SNOW ROAD COMMERCIAL PARK SUBDIVISION

APPLICATION NUMBER 16 DATE June 1, 2006

REQUEST Subdivision

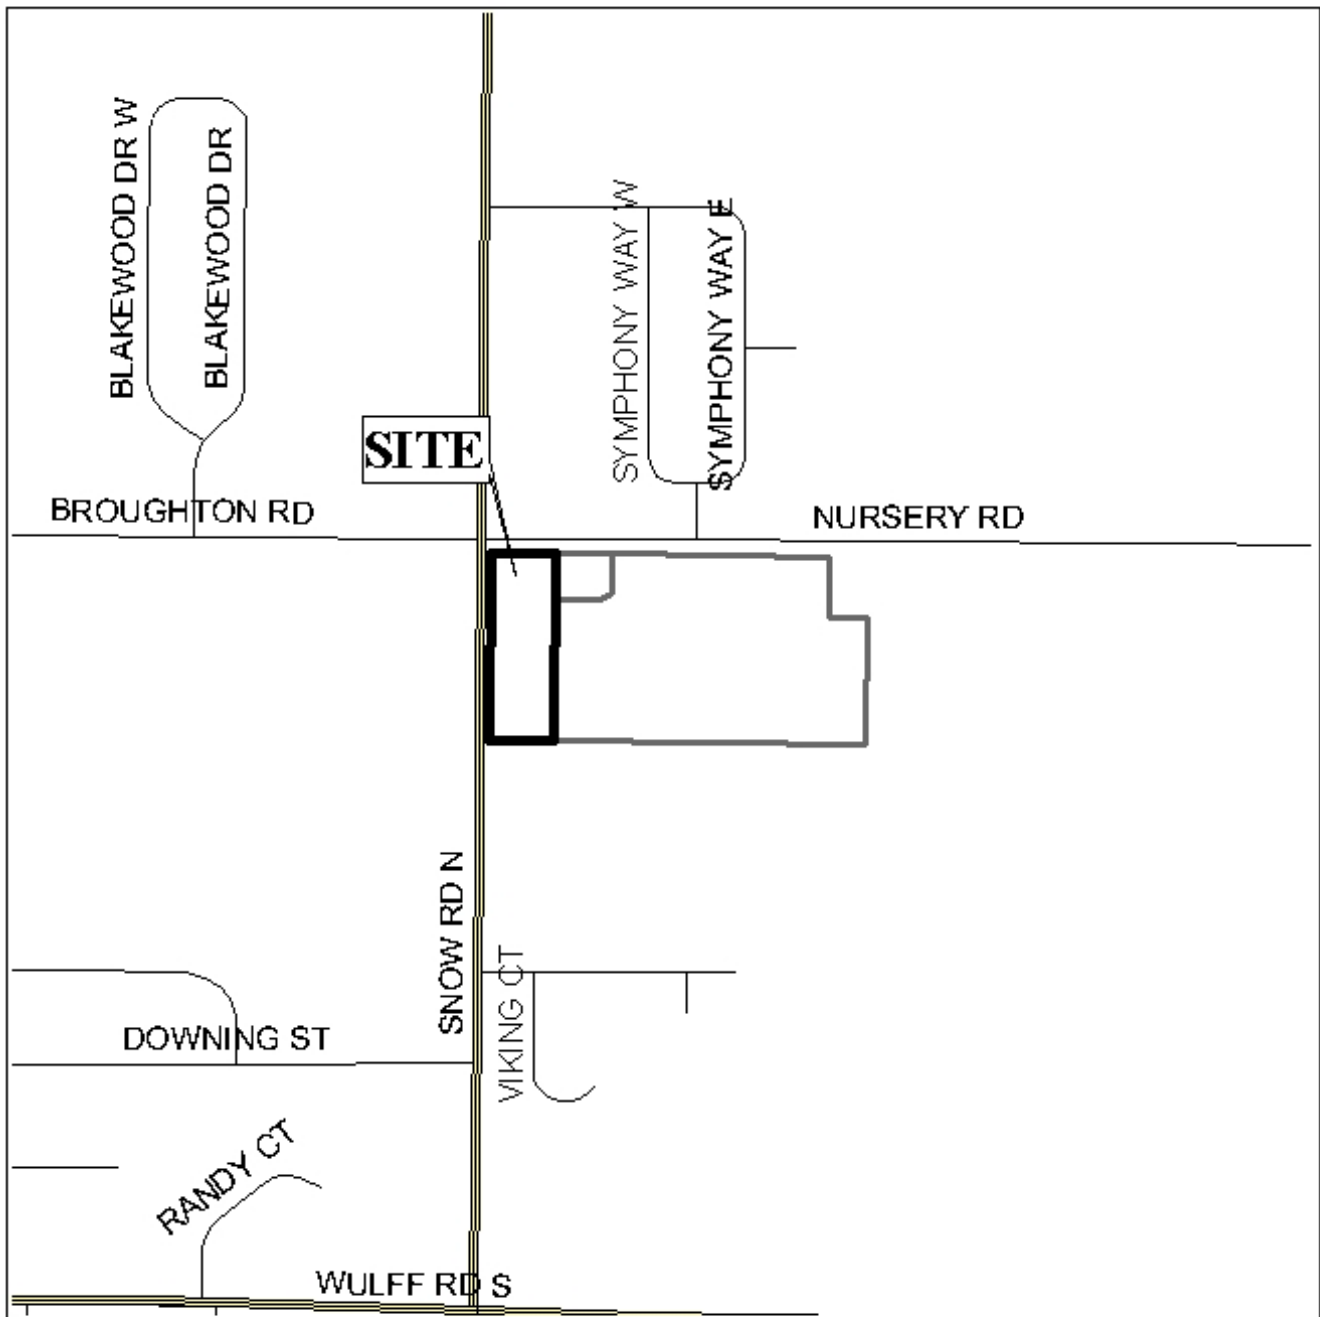
The site fronts onto Snow Road, a proposed major street, and Nursery Road, a minor street. Snow Road should have a right-of-way width of 100 feet instead of the existing 80 feet, and the preliminary plat depicts additional land “reserved for future widening” – this 10-foot strip of land must be dedicated to Mobile County. Nursery Road has an adequate right-of-way, however, the preliminary plat indicates that the right-of-way is 80 feet, while GIS data indicates the right-of-way may be 60 feet in width: the width should be verified with County Engineering and the plat revised if necessary.

Access management is a concern due to site fronting onto Snow Road and having a corner lot condition. Lot “A” should be limited to one curb-cut onto Nursery Road, and one curb-cut onto Snow Road. Lots “B” and “C” should be limited to one shared curb-cut, and Lots “D” and “E” should be limited to one shared curb-cut. The size, design and location of all curb-cuts must be approved by County Engineering.

As Lots A-E are designated for commercial development, a note should be placed on the final plat stating that a buffer, in compliance with Section V.A.7. shall be provided where the commercial properties adjoin residential property.

The plat meets the minimum requirements of the Subdivision Regulations and is recommended for Tentative Approval, subject to the following conditions: 1) dedication of sufficient right-of-way to provide a minimum of 50 feet from the centerline of Snow Road; 2) revision of the plat, if needed, with the correct Nursery Road right-of-way width; 3) placement of a note on the final plat stating that lot “A” is limited to one curb-cut onto Nursery Road, and one curb-cut onto Snow Road, that lots “B” and “C” are limited to one shared curb-cut, and that lots “D” and “E” are limited to one shared curb-cut, with the size, design and location to be approved by Mobile County Engineering; and 4) placement of a note on the final plat stating that a buffer, in compliance with Section V.A.7. shall be provided where the commercial properties adjoin residential property.
